Parks Commission

City of South Haven

Dyckman Beach Access

Kid's Corner Play Structure

ENTRY TREATMENT - OPTION A

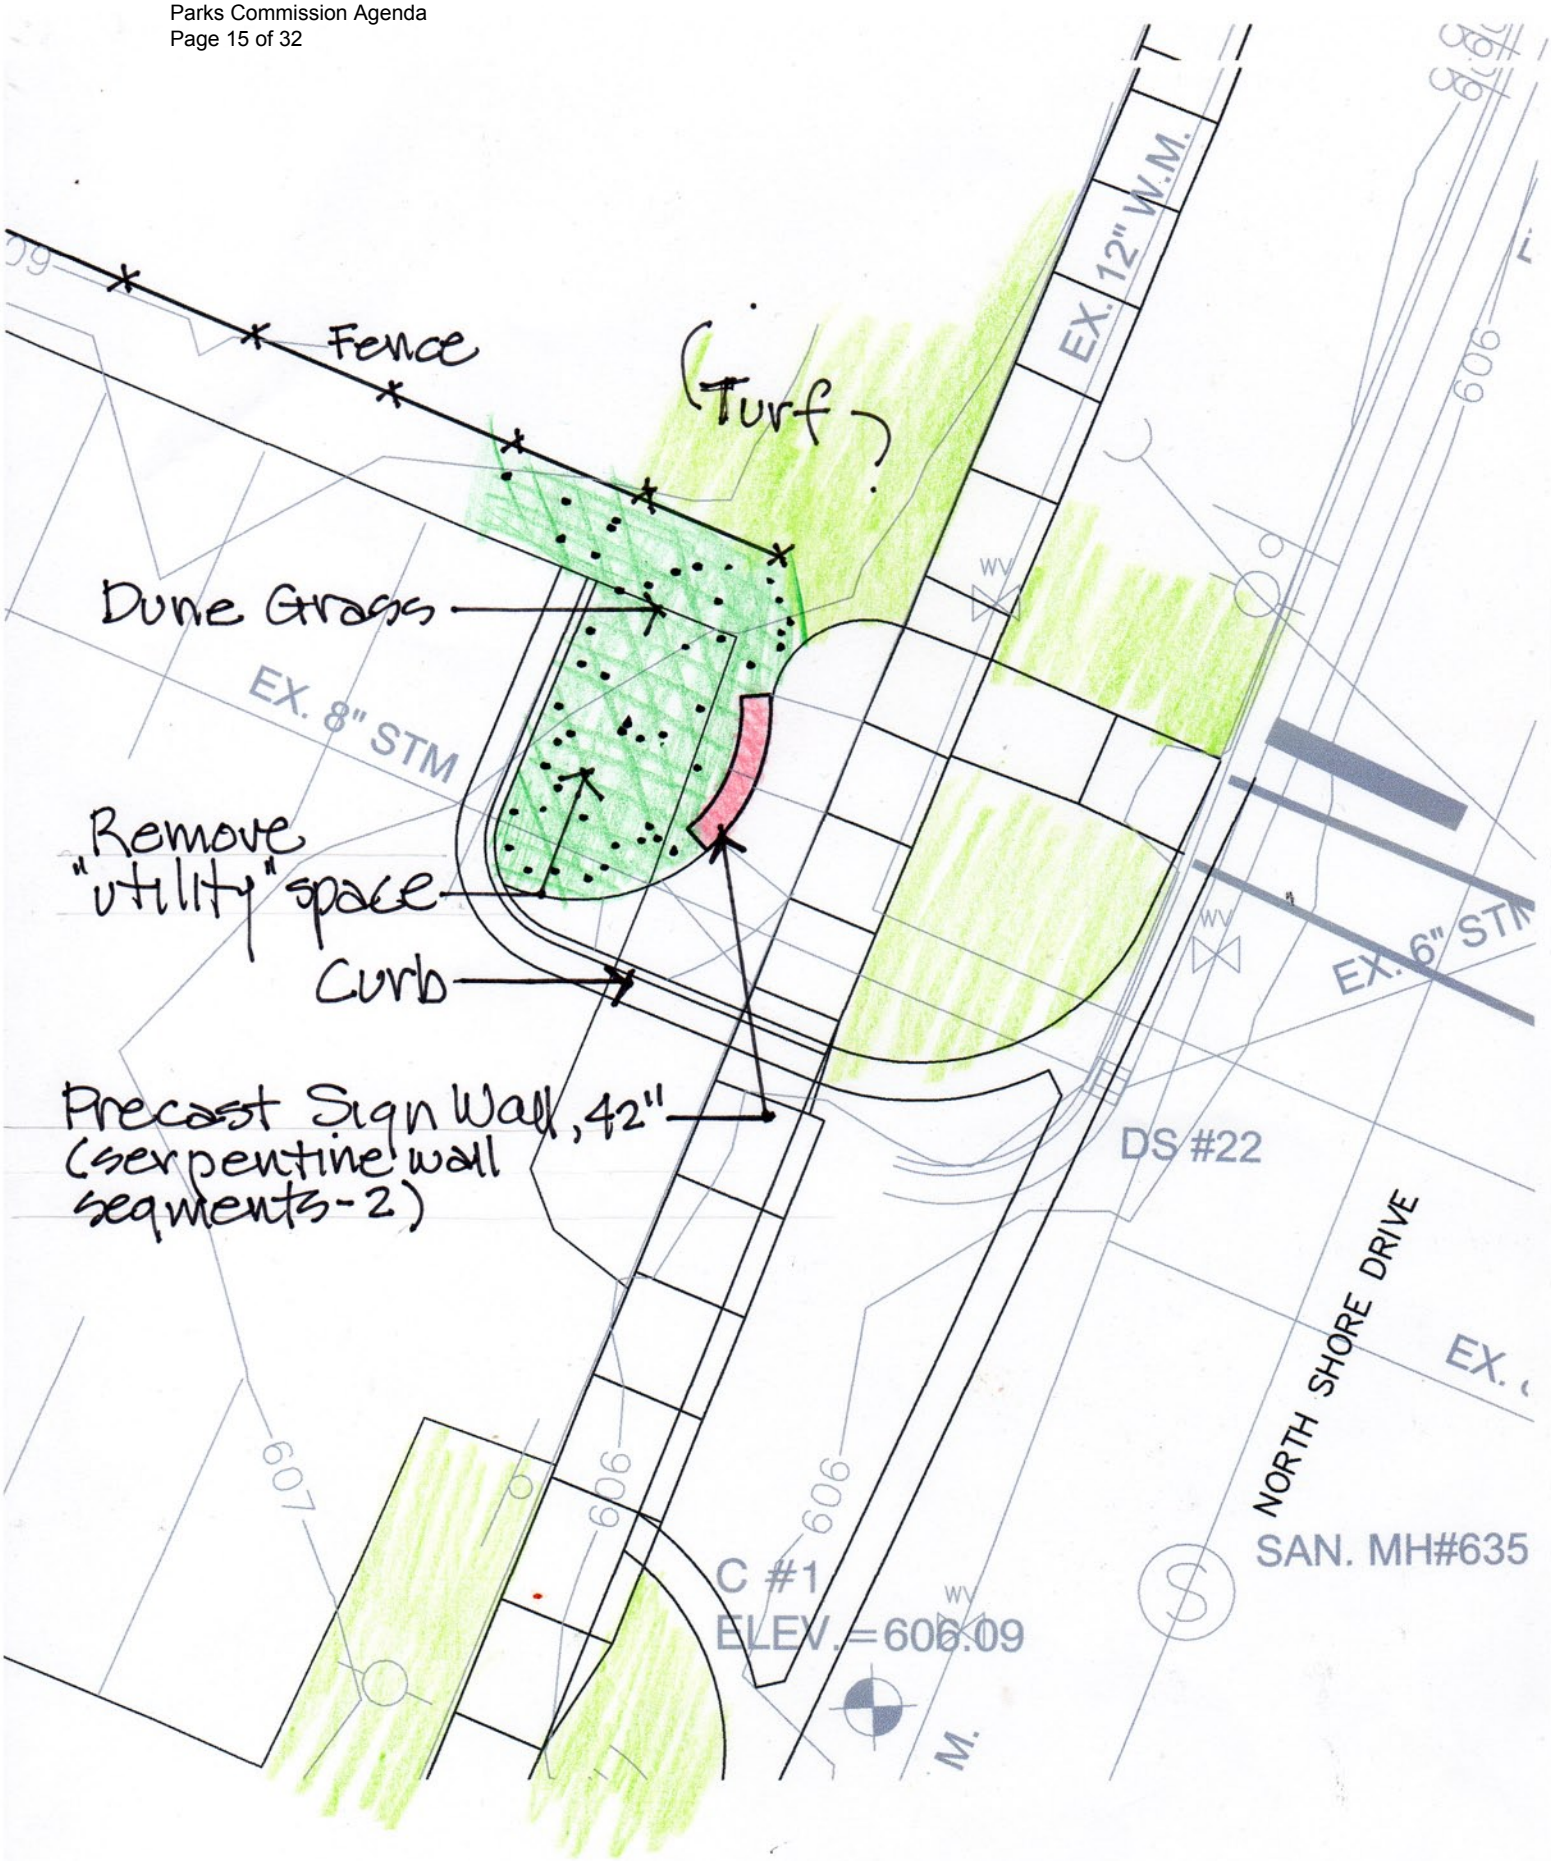
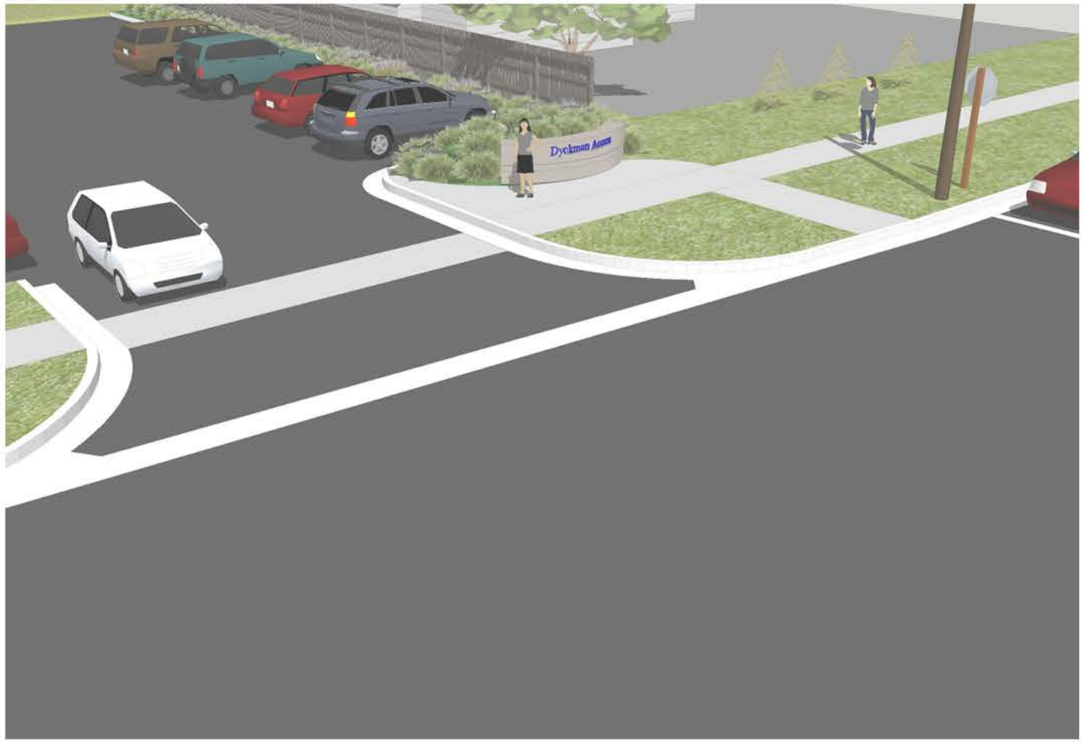
Halberstadt noted that Option A will have a bench, curved like the seat walls in front of City Hall, with the name of the park on the bench. The intersection will still be a 4-way stop and the driveway will be widened. Option A is a little more expensive because those seat walls can be a little expensive, so the designer, Pat Cornelisse, thought she would provide some other options.

Option A would utilize a precast concrete seat wall with the name of the park attached in raised letters. Samples of the precast concrete seat wall can be seen at South Beach and in front of City Hall.

The wall is nice in Option A, as I can see people stopping for a rest by taking a seat on the wall. The wall should be low so as not to block the view of the water. I also believe it is important to have the park hours posted upon entry, so I would like the park hours to be included somehow on the block wall, not as an additional sign to the area. Please do not put beach grass behind the wall! Do not block the view of the water with vegetation. I would encourage only low growing plantings behind the wall. Cars will be blocking the view 3 months out of the year, but I look at that view driving down Dyckman Avenue 12 months out of the year, as do many year round residents :) Please keep the view open to the water, and do not block with a tall sign or tall vegetation. I also like Option A as the sidewalk runs up to the block wall, and this would eliminate the Parks crew from having to mow that small area between the block wall and the current sidewalk area.

Dyckman Access
ENTRY TREATMENT - OPTION B
SCALE: 1" = 10'

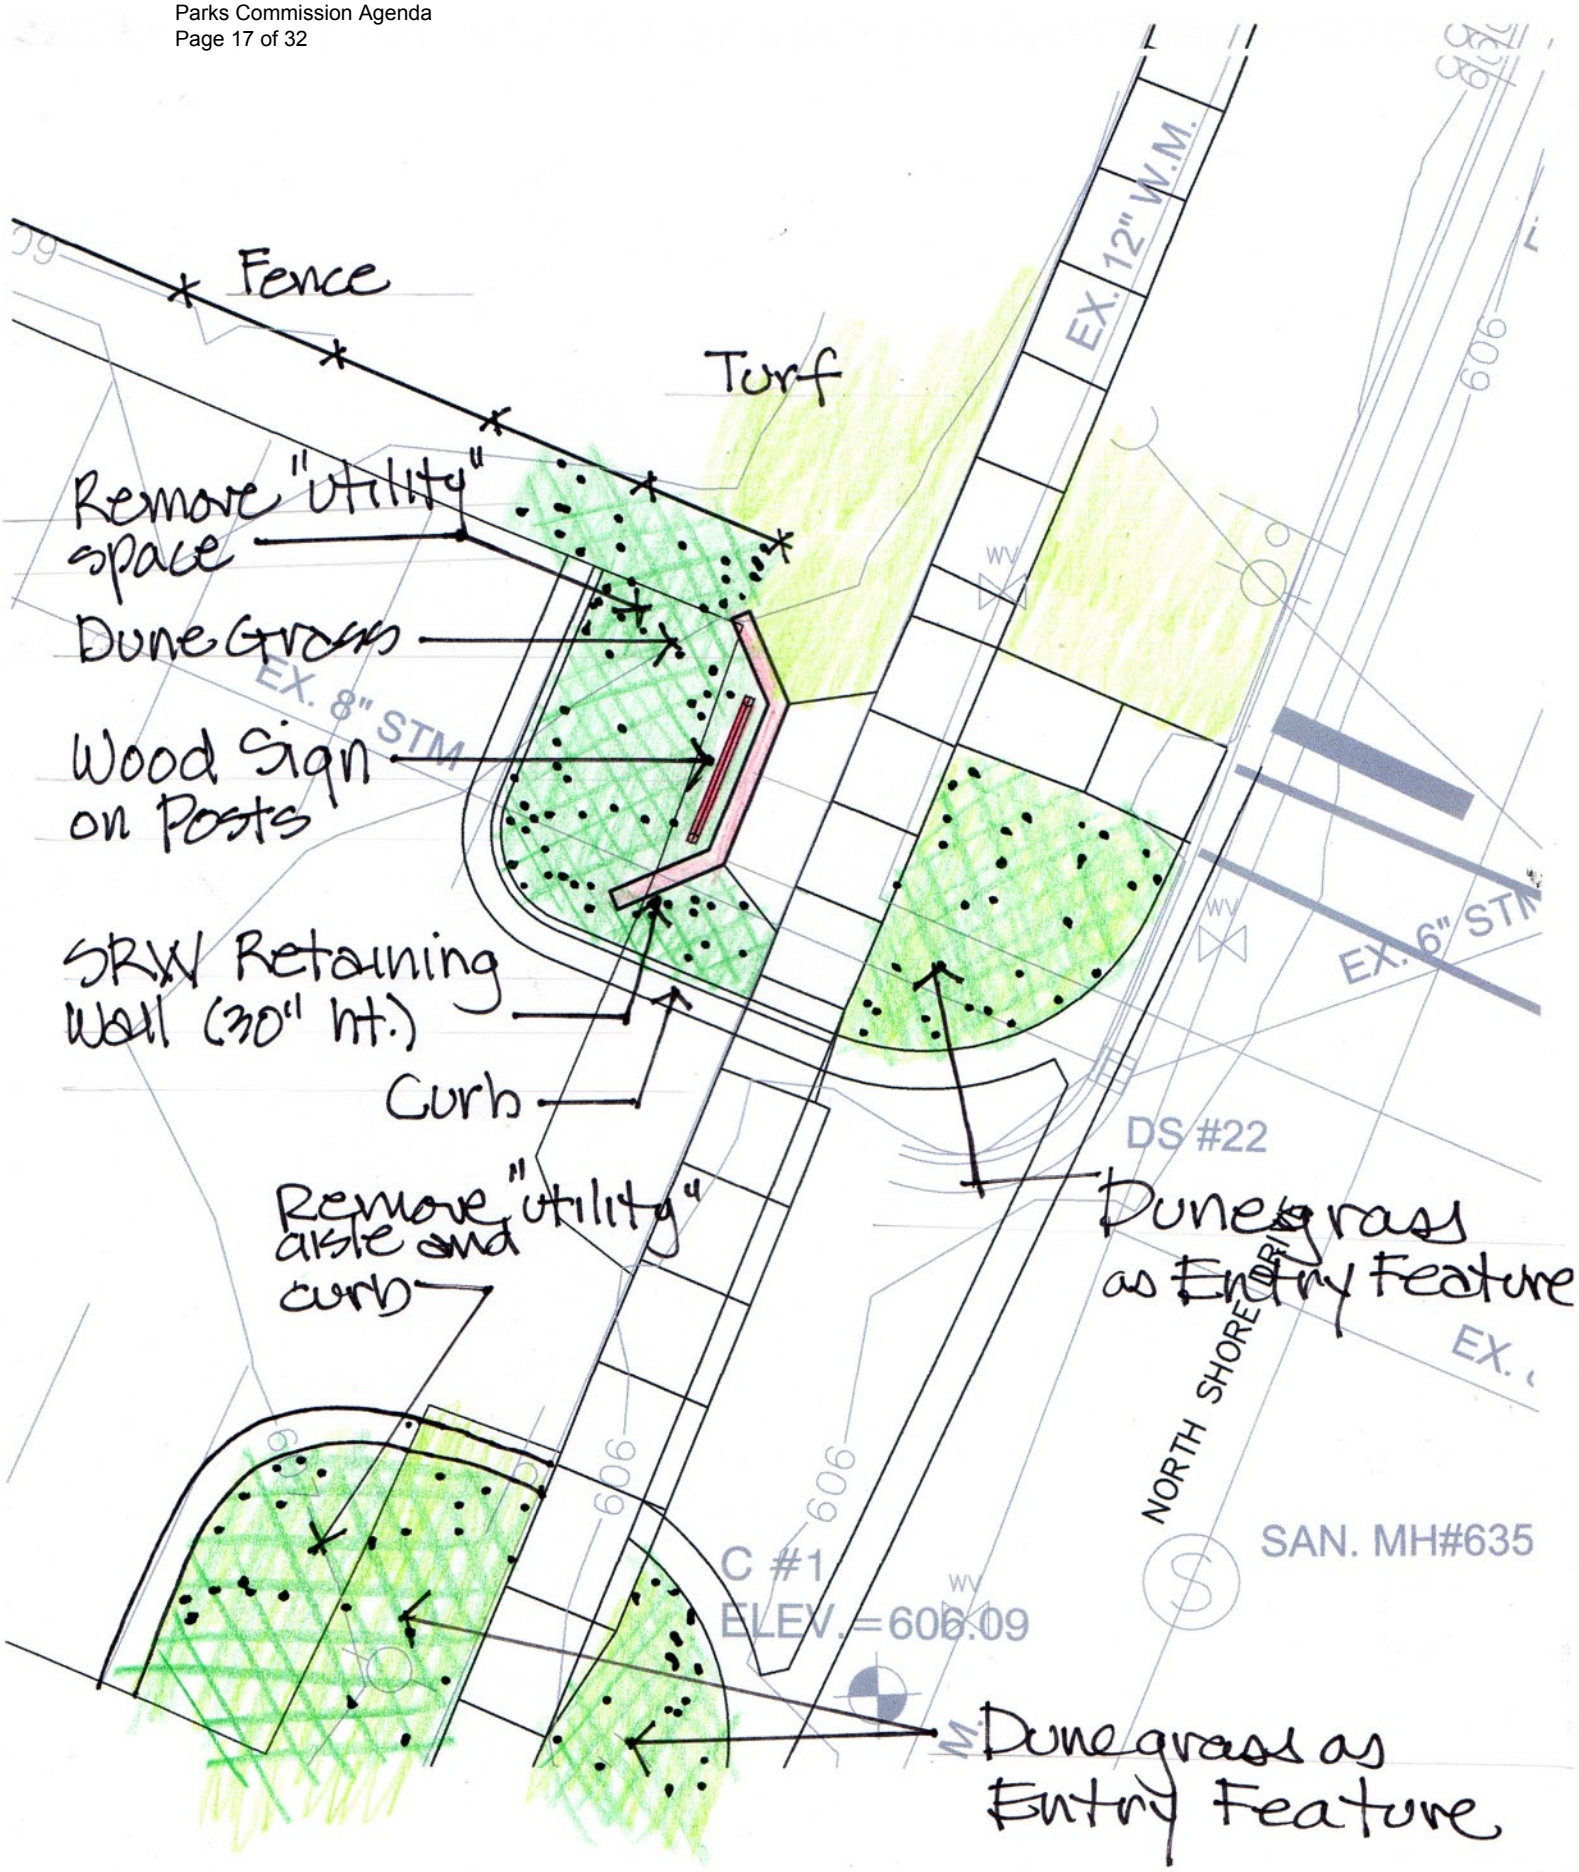
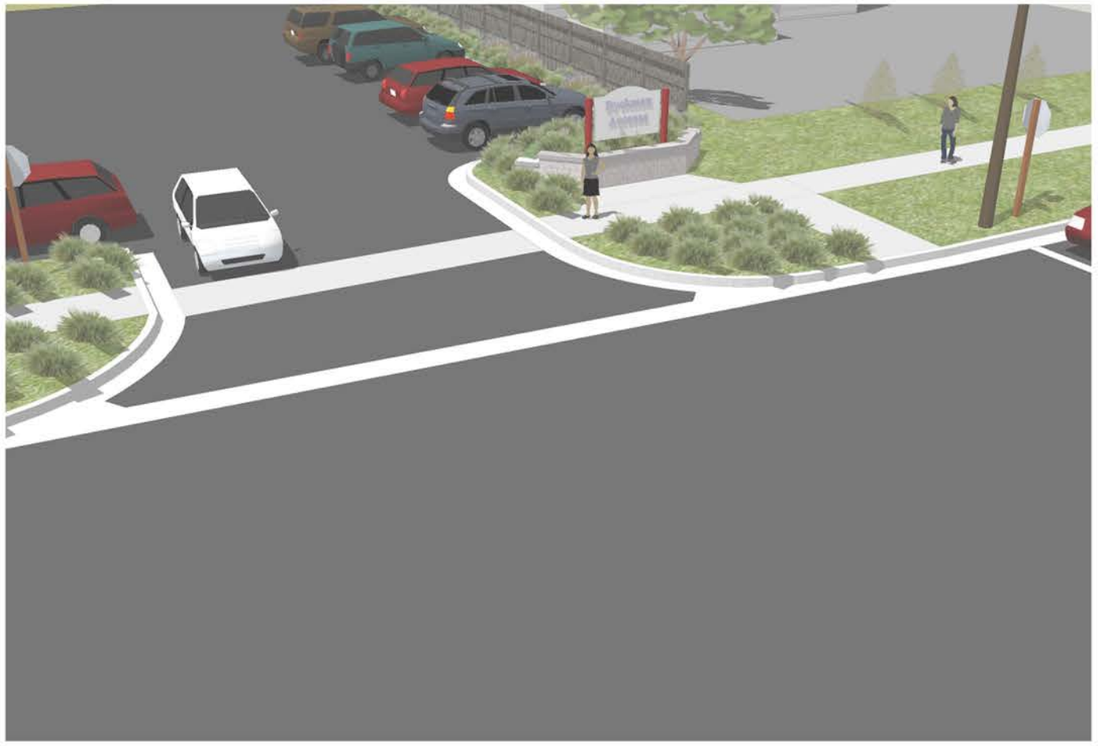
Option B has a freestanding sign with a little masonry wall in front of it, Halberstadt pointed out.

Please rule out Option B. I absolutely disagree with the idea of putting any vegetation besides grass in the parkway area, I absolutely want to eliminate Option B. As I stated at the last meeting, beach grass is overdone in our area. In option B, any vegetation at all in the City right of way, is a bad idea. Tall vegetation, such as beach grass will block the sight line for cars, bicycles, and pedestrians. Low vegetation near the roadway is also a bad idea, keep it grass.
